**Docket Items #14**  
**Development Site Plan #2012-00034**  
**ACPS Modular Classroom and Cafeteria Addition(s)**  
**— George Mason Elementary School**

<b>Purpose of Applications</b>
<ul style="list-style-type: none"> <li>Development site plan approval for George Mason Elementary school to construct four (4) modular classrooms and one (1) modular cafeteria addition in two (2) phases.</li> </ul>

<b>Staff Recommendation: APPROVAL WITH CONDITIONS</b>
<b>Staff Reviewers:</b> Tony Somers, <a href="mailto:Tony.Somers@alexandriava.gov">Tony.Somers@alexandriava.gov</a> Gary Wagner, <a href="mailto:Gary.Wagner@alexandriava.gov">Gary.Wagner@alexandriava.gov</a>

Design Recap - Revised 4 Classroom Floor Plan

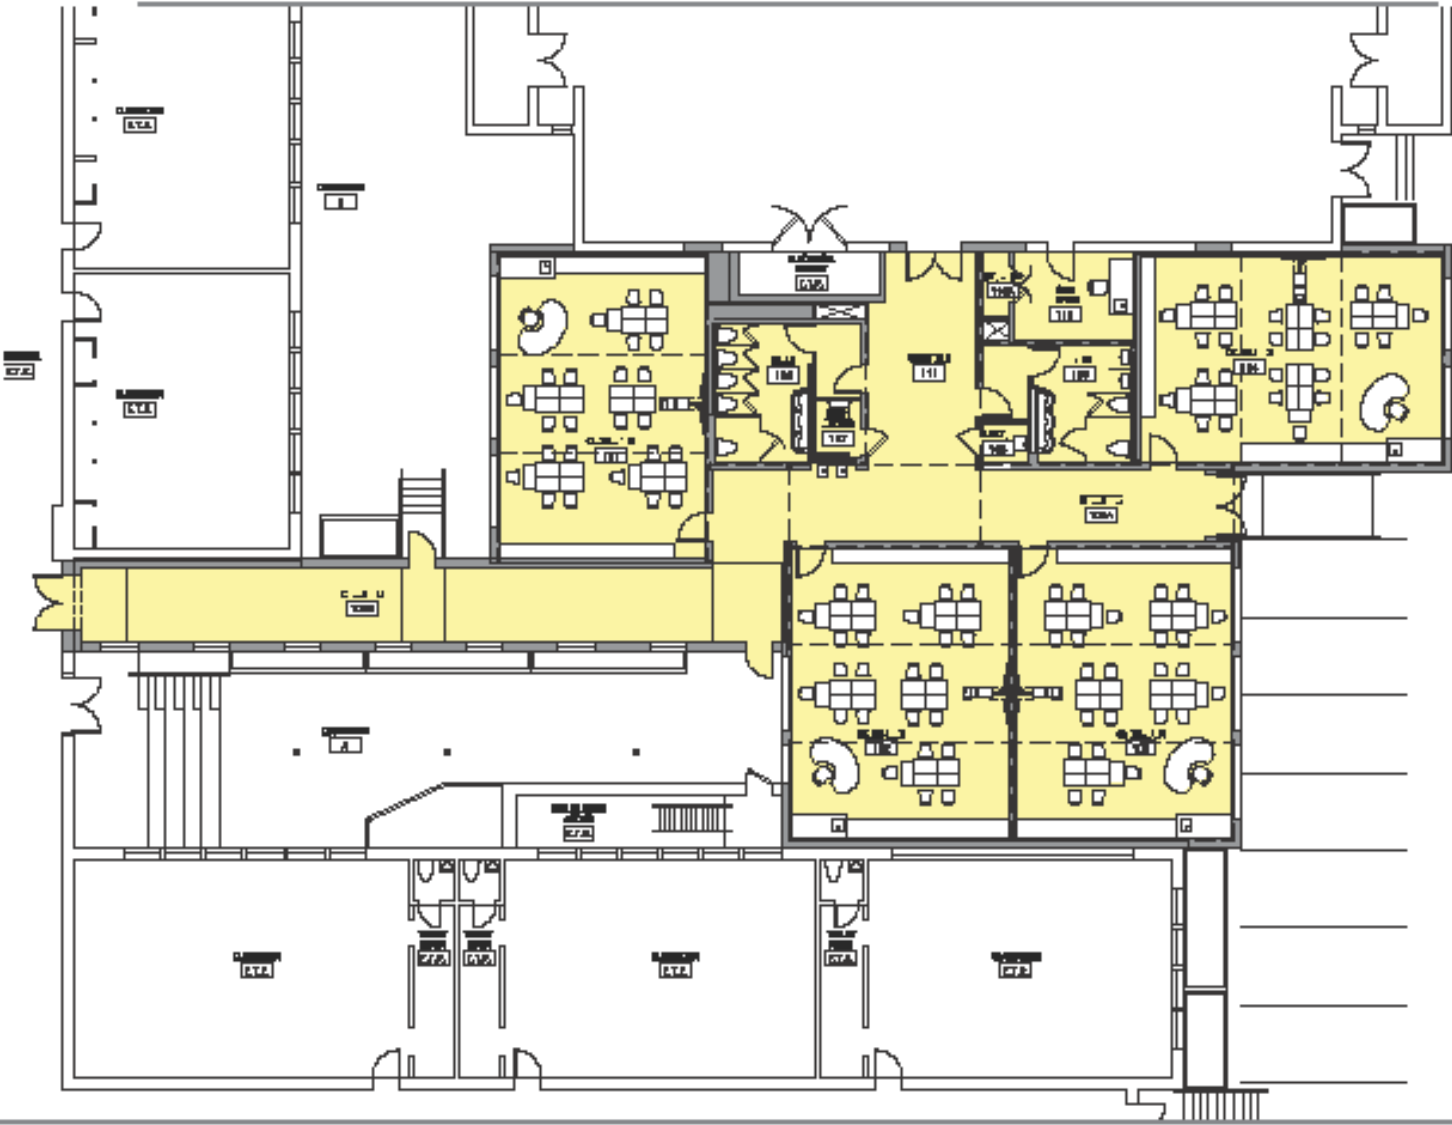
1. The Final Site shall be in substantial conformance with the preliminary plan dated March 15, 2013—with the exception that the modular classrooms shall reflect the recently proposed four (4) unit configuration, not six (6) units—and comply with the following conditions of approval.

# □ Design Development- Elevations

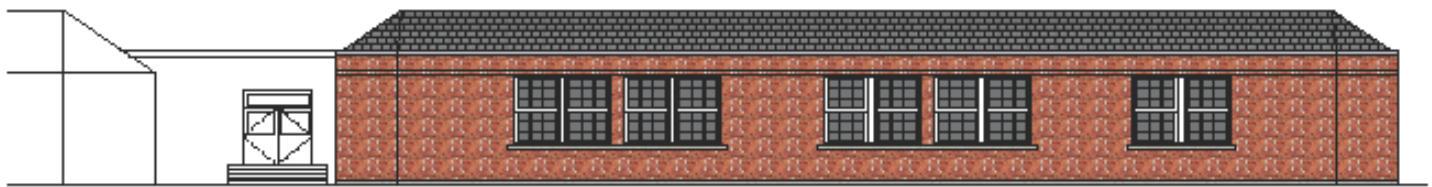
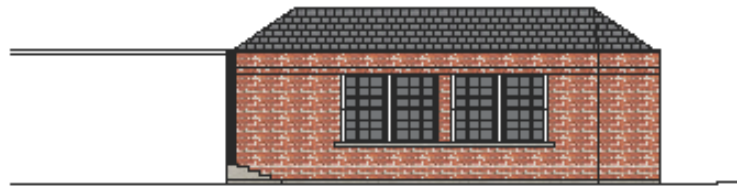
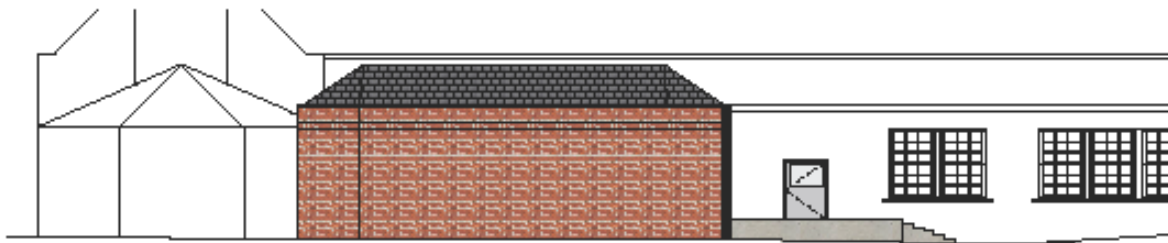
17. The phase two modular kitchen addition roof shall be extended to better reflect the line and scale of the existing school roof. (P&Z)
18. All trim on the existing building shall be reflected in the modular kitchen addition. This includes the white trim under the roof line and the meeting of the windows with said trim. (P&Z)
